Economic Commission for Europe**Inland Transport Committee****World Forum for Harmonization of Vehicle Regulations****171st session**

Geneva, 14-17 March 2017

1958 Agreement:**Consideration of draft amendments****to existing Regulations submitted by GRSG****Proposal for the 03 series of amendments to Regulation
No. 118 (Burning behaviour of materials)****Submitted by the Working Party on General Safety Provisions***

"Figure 1
Specimen holder (Dimensions in millimetres)

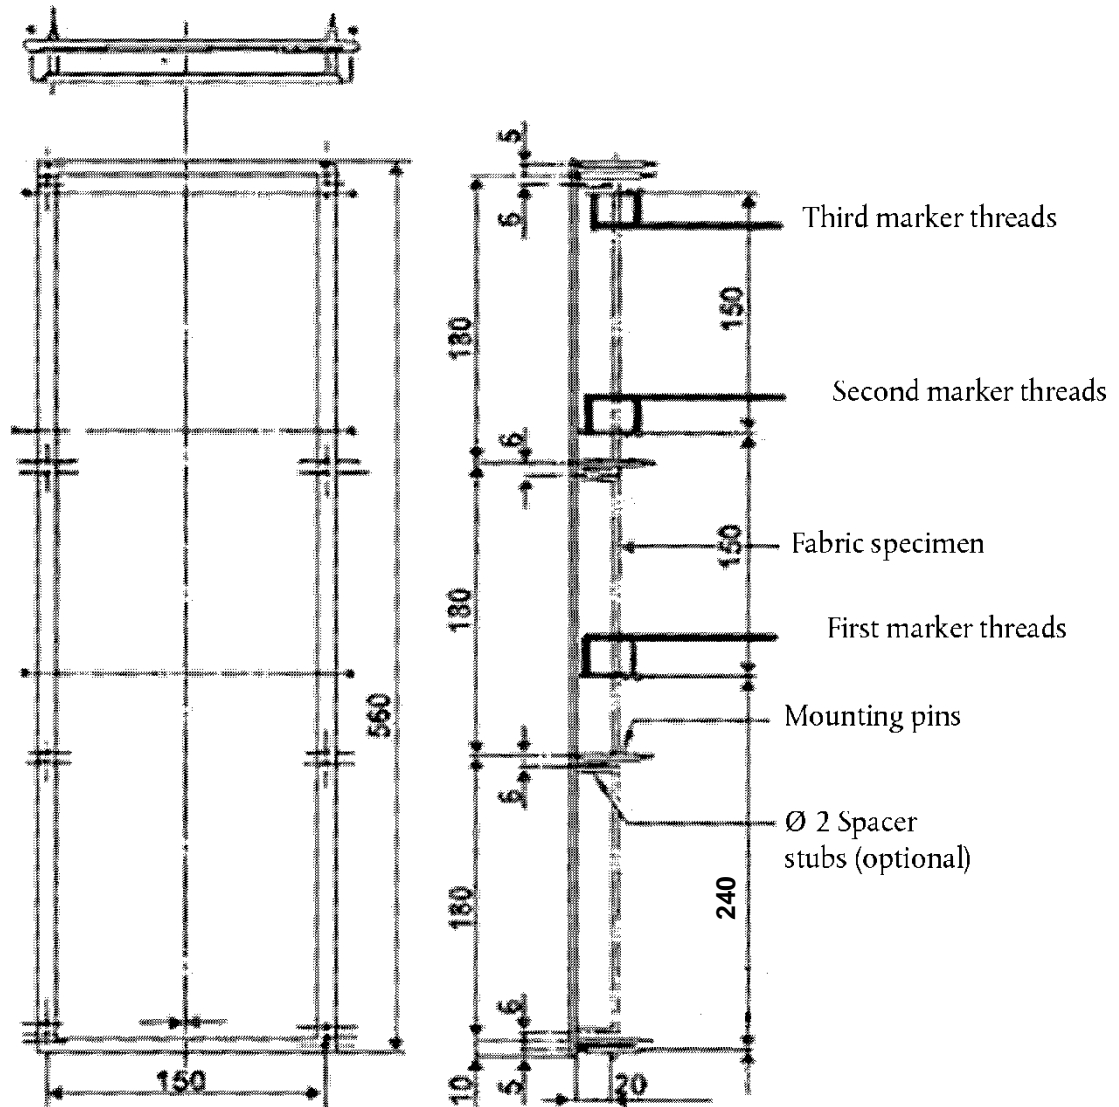
Figure 1, amend to read (removing "Burner" at the bottom and replacing "220" by "240"):
